DEVELOPMENT ASSESSMENT REPORT

Application No.	DA/2023/0989
Address	50 Glassop Street BALMAIN
Proposal	Installation of solar tiles on front roof plane. Remainder of roof to have existing tiles removed and replaced with standard tiles.
Date of Lodgement	26 November 2023
Applicant	Mr Richard J Paoloni
Owner	Mr Richard J Paoloni
Number of Submissions	Two (2)
Value of works	\$50,000.00
Reason for determination at Planning Panel	Recommended refusal on a site containing a heritage Item
Main Issues	<ul style="list-style-type: none"> • Non-compliance with heritage controls • Incompatibility with the streetscape and desired future character controls
Recommendation	Refusal
Attachment A	Reasons for refusal
Attachment B	Draft conditions of consent (in the event the Panel resolves to approve the application)
Attachment C	Plans of proposed development
Attachment D	Statement of Heritage Impact
Attachment E	Applicant Response to Council Withdrawal Request

Figure 1: subject property outlined in green

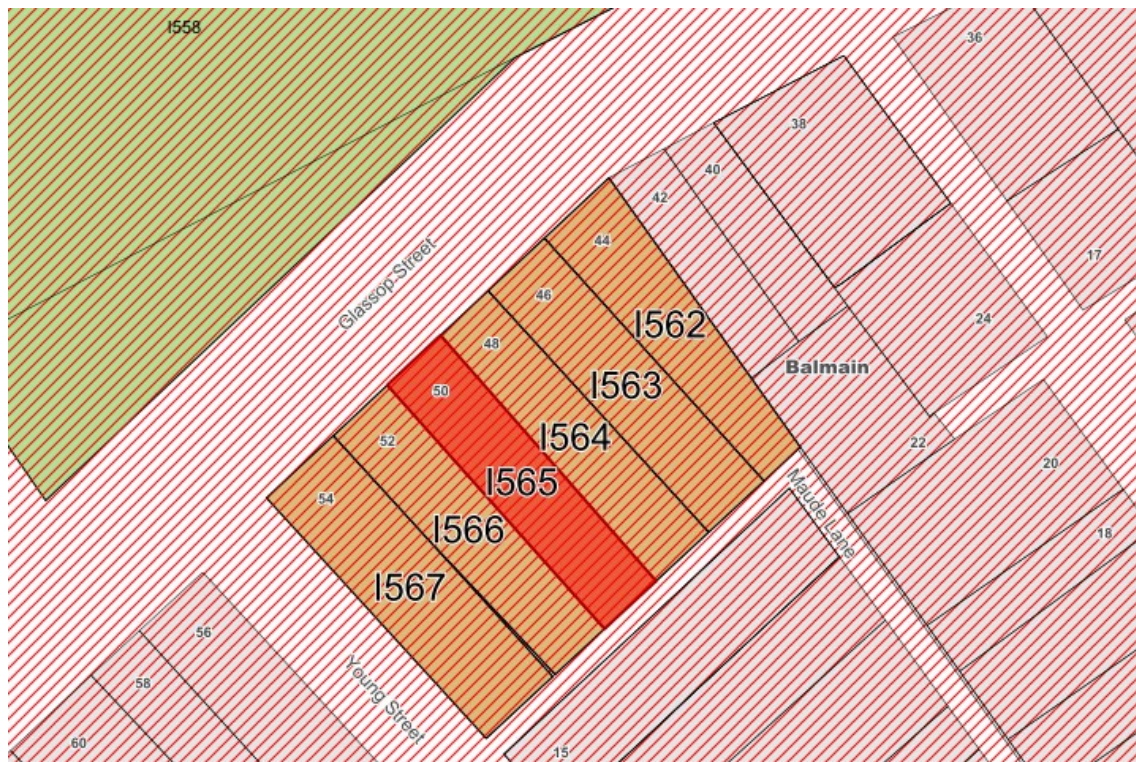
The subject site is located on the south-eastern side of Glassop Street between Young Street and Hampton Street and is opposite Elkington Park. The site is legally described as lot 2 in DP 923768, is generally rectangular shaped with a total area of 219.4 sqm — see figure 1 for aerial view.

Figure 2: Heritage Map with the subject site in red, heritage items in brown, heritage listed park in green and HCA hatched in red.

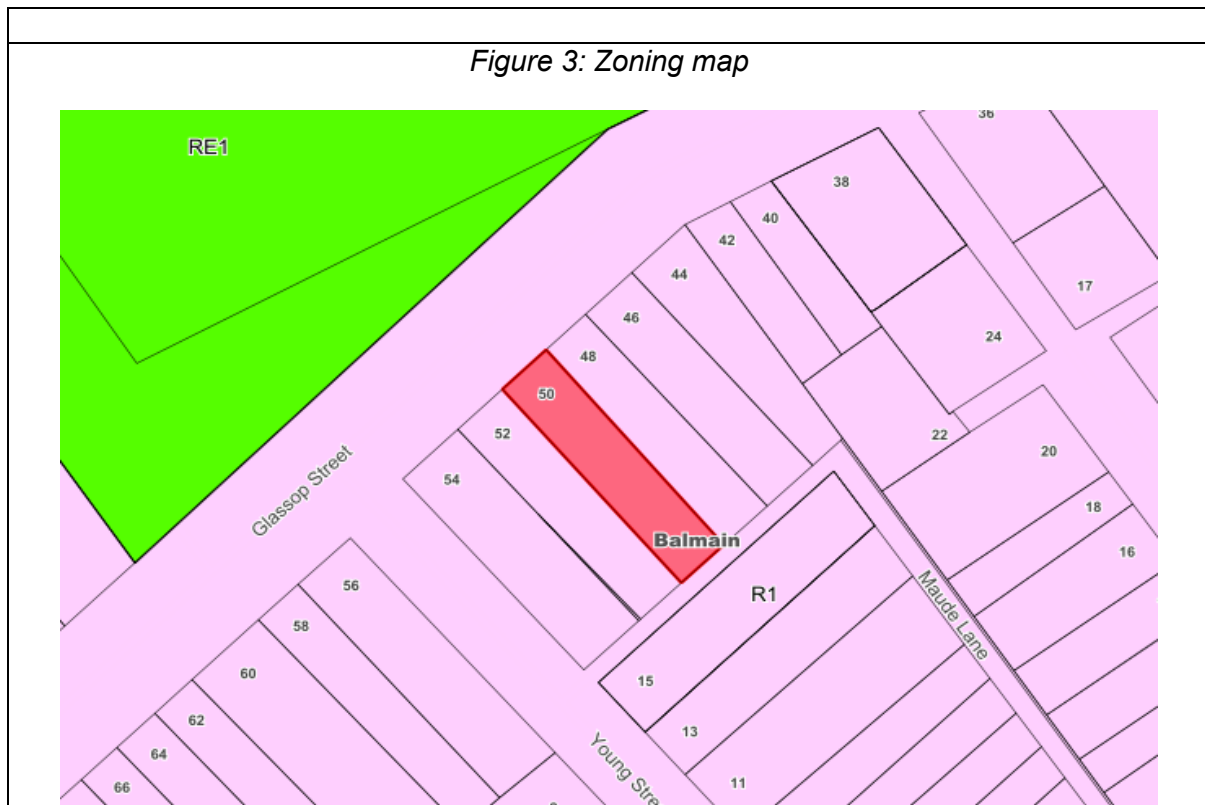
The subject site is listed as a local heritage item (item I565) and is part of a group of six heritage listed terraces including numbers 44, 46, 48, 52, and 54 Glassop Street – see figure 2. The subject site is opposite the heritage listed Elkington Park and located within The Iron Cove Heritage Conservation Area (HCA).
